2015-2016 SLICE

Rear Brake Mount Inspection

About this Service Bulletin

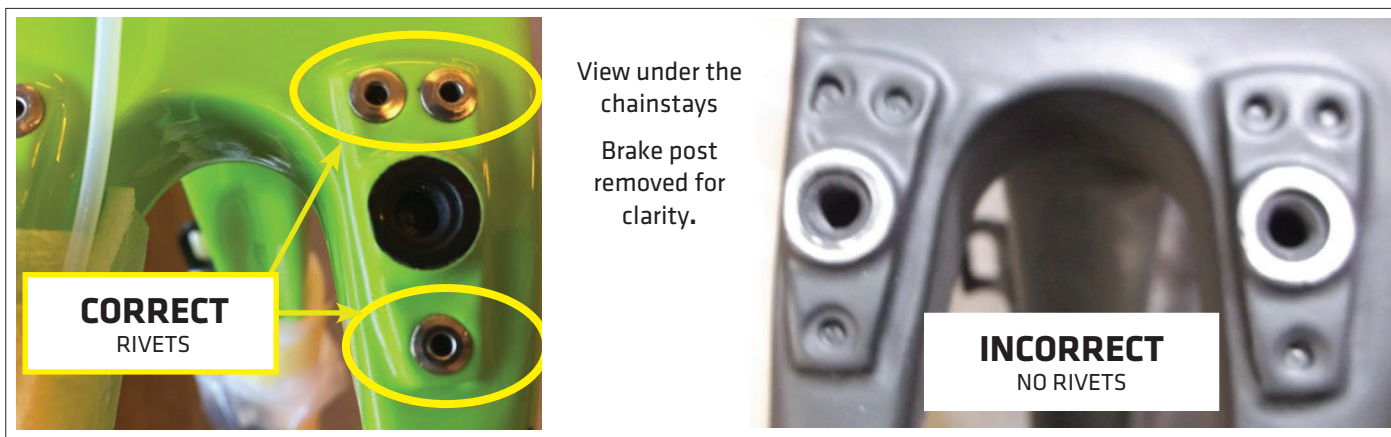
It has come to our attention that some 2015-2016 Slice models may have missing rear brake mounting plate rivets. A very small number of frames may have shipped missing the rivets. The rivets are required reinforcement of the bonded brake mounts. If the rivets have not been installed in a frame, as shown below left, the frame must be replaced.

For the 2015-2016 Slice models listed below, please inspect any inventory that is in stock to make sure that the rivets are installed, above left. During routine service of any customer bikes, please check for the rivets on the rear brake mount. If all the rivets are in place, the bicycle is OK and no further action is required.

If the rivets are missing, see above right, please contact CSG Technical Support for information on how to obtain a warranty replacement frame. See contact information below.
